**15-DAY EXPRESS TERMS
FOR PROPOSED BUILDING STANDARDS
OF THE CALIFORNIA STATE LANDS COMMISSION
REGARDING THE 2019 CALIFORNIA BUILDING CODE,
CALIFORNIA CODE OF REGULATIONS, TITLE 24, PART 2**

**CHAPTER 31F – MARINE OIL TERMINALS
CHAPTER 35 – REFERENCED STANDARDS
(SLC-01-18)**

15-DAY EXPRESS TERMS

FIGURE 31F-2-1

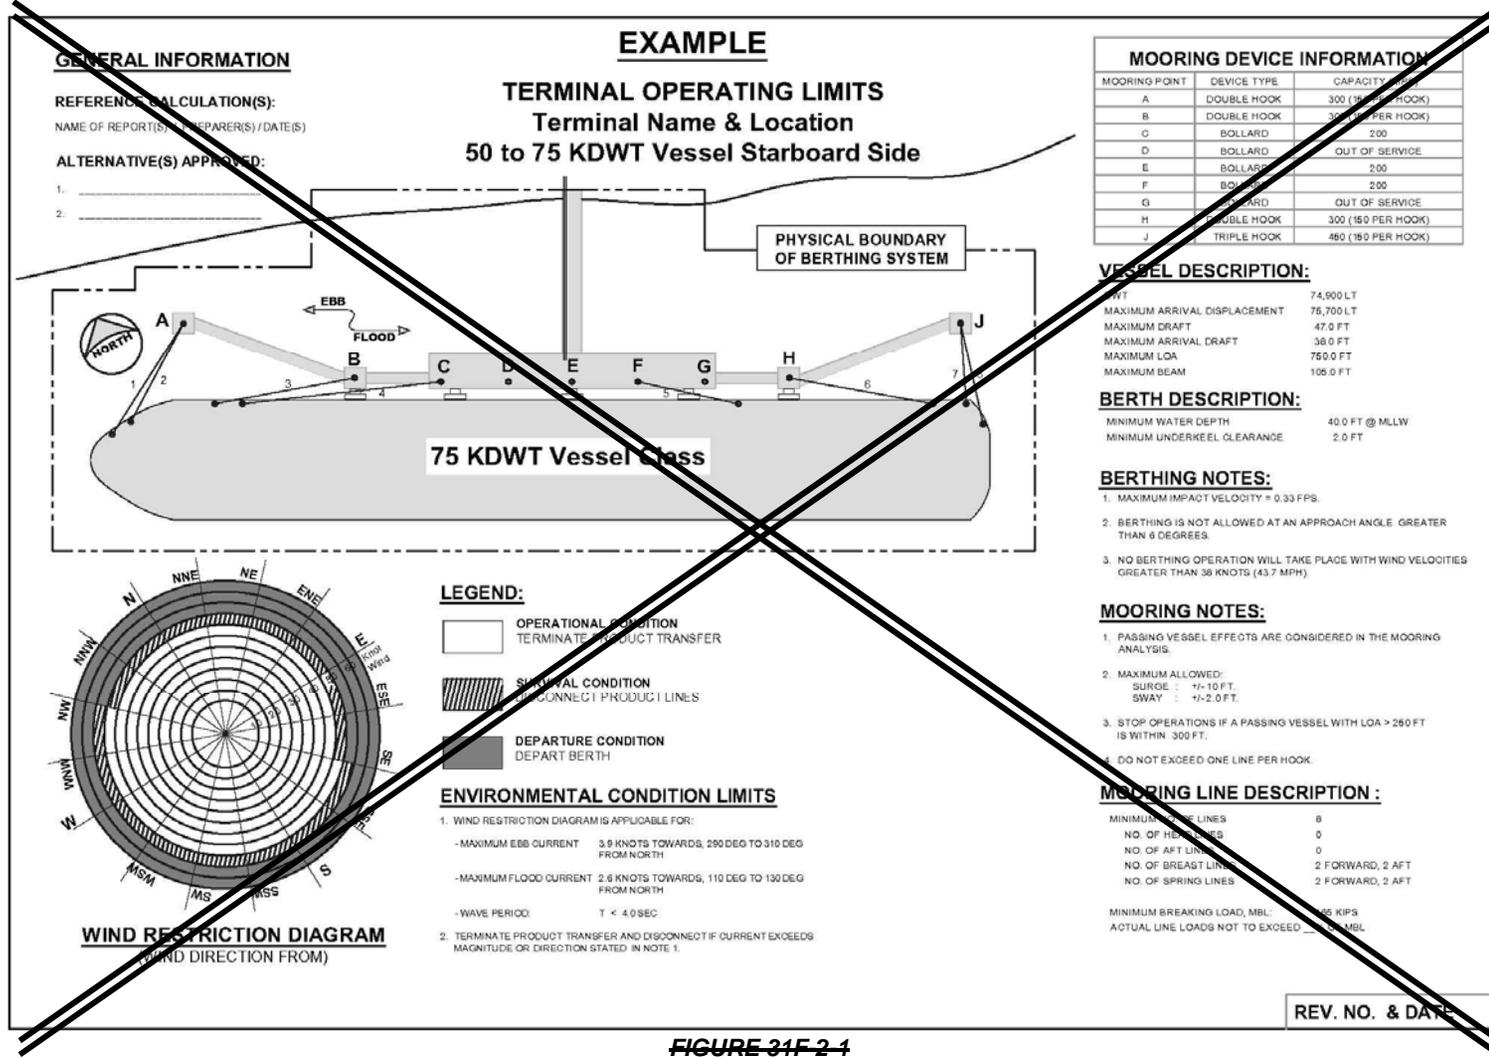
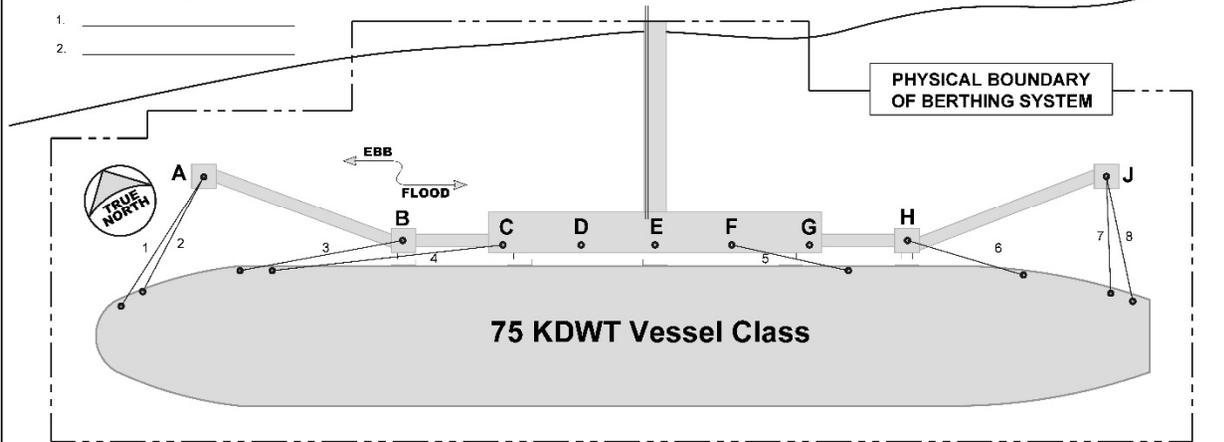
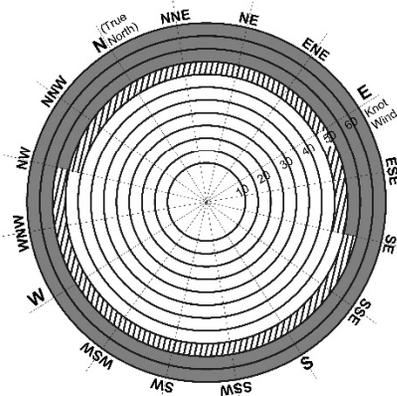
2.8. Replace Figure 31F-2-1:

RATIONALE: The proposed “EXAMPLE” language in Figure 31F-2-1 is amended with the following sufficiently related and non-substantive amendments:

- (a) **VESSEL HULL SHAPE** – Based on public comment, the vessel hull shape is updated to be more representative of a tanker.
- (b) **TERMINATE PRODUCT TRANSFER** – Based on public comment, for clarity, the location of the terminology “*TERMINATE PRODUCT TRANSFER*” is adjusted with the relocation of this terminology to the “*SURVIVAL CONDITION*” zone in the wind restriction diagram legend, allowing for unrestricted transfer operations within the “*OPERATIONAL CONDITION*” wind envelope, and providing consistency with the proposed Sections 3103F.5.2.2.1 (Express Term #3.14) and 3103F5.2.2.2 (Express Term #3.15) language. In general, the range of the “*SURVIVAL CONDITION*” wind zone is defined by “*TERMINATE PRODUCT TRANSFER*” threshold as the lower bound and “*DEPARTURE CONDITION*” threshold as the upper bound, with “*DISCONNECT PRODUCT LINES*” occurring within the zone.

- (c) **UNITS OF MEASUREMENT & DIRECTIONALITY FOR WIND** – Based on public comment, the terminology “*True*” is added to the north direction arrow and the terminology “(*True North*)” to the “*WIND RESTRICTION DIAGRAM*” to clarify that units of measurement and directionality shall be specified in Terminal Operating Limits diagrams.

- (d) **VESSEL CLASS MARKING** – During the 45-day Comment Period, the Commission staff discovered a minor graphical error in this Express Term, where a white box was placed around the “*75 KDWT Vessel Class*” marking on the vessel image. Therefore, this white box is removed in the amended language.

- (e) **DWT Capacity** – Based on a public comment received regarding proposed amendments to Section 3105F.2 (ref. Express Term #5.4), Commission staff became aware of potential ambiguity in the use of the terminology “*DWT*” when defining vessel sizes. Therefore, the terminology “*Capacity*” is added after “*DWT*” in the “*Vessel Description*” section for clarity and consistency when expressing vessel size (e.g., see item 3 in existing Section 3101F.6). This change is without regulatory effect.
